TECHNICAL SERVICE BULLETIN

Illuminated MIL With DTCs P0455, P0456, P0442 And/Or P04EE

25-2308

Ford
2022-2024 Maverick

Figure 1 - Location Of The Chafing/Rubbing Condition

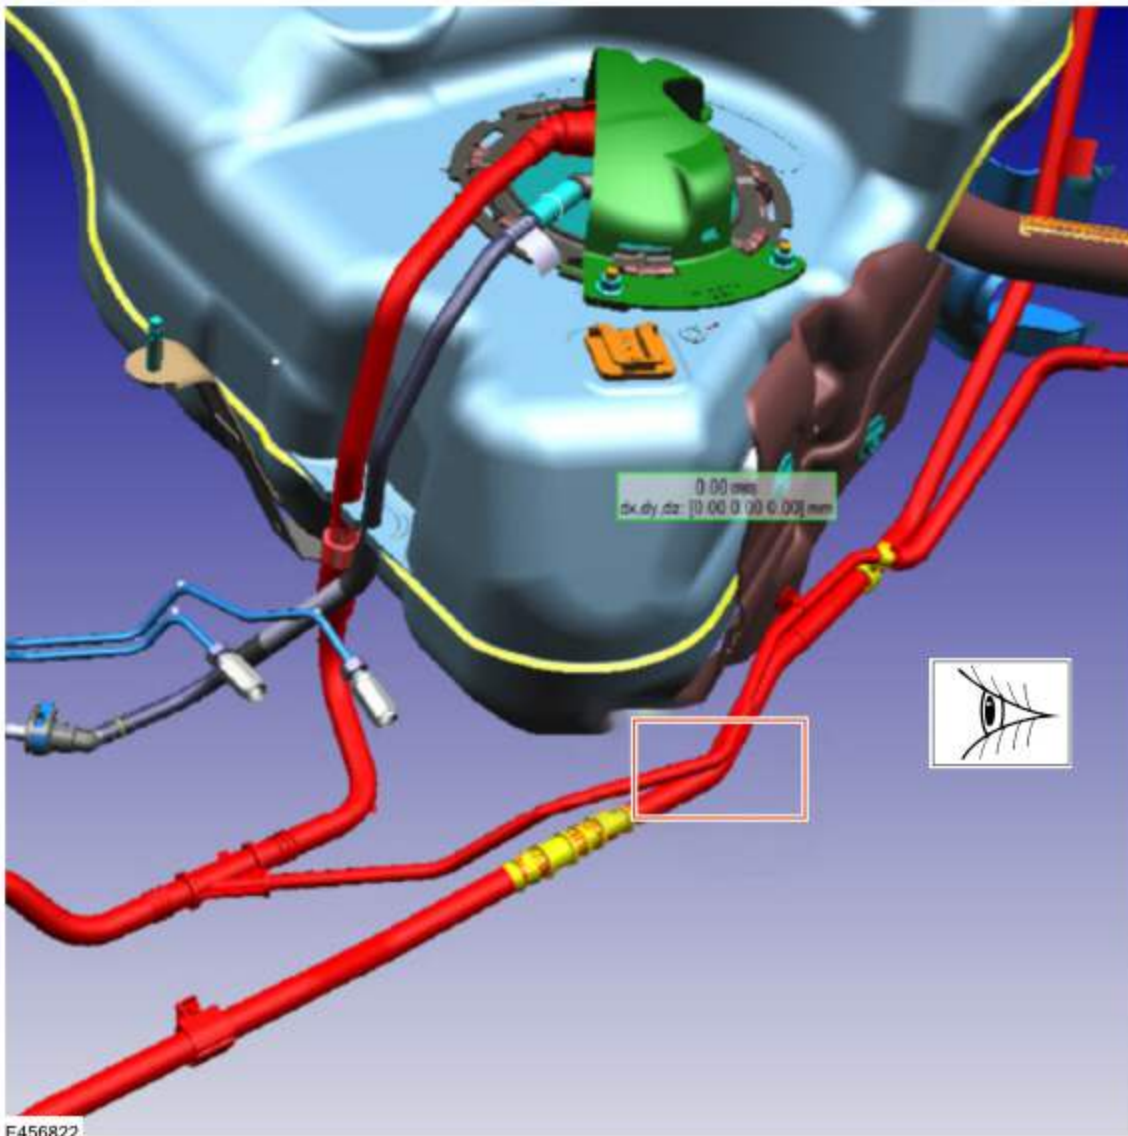
Issue: Some of the vehicles listed in the Model statement above may exhibit an illuminated MIL with DTCs P0455, P0456, P0442 and/or P04EE. This may be due to a chafing or rubbing condition between the fuel vapor canister line and the air vent hose.

1. Inspect the fuel vapor canister line for chafing or rubbing damage caused by contact against the air vent hose. Is the fuel vapor canister line damaged due to chafing or rubbing contact against the air vent hose? (Figure 1)

Action: For vehicles that meet all of the criteria in the Issue and Model statements, follow the Service Procedure to install a new fuel vapor canister line that includes a clip to maintain the gap with the air vent hose.
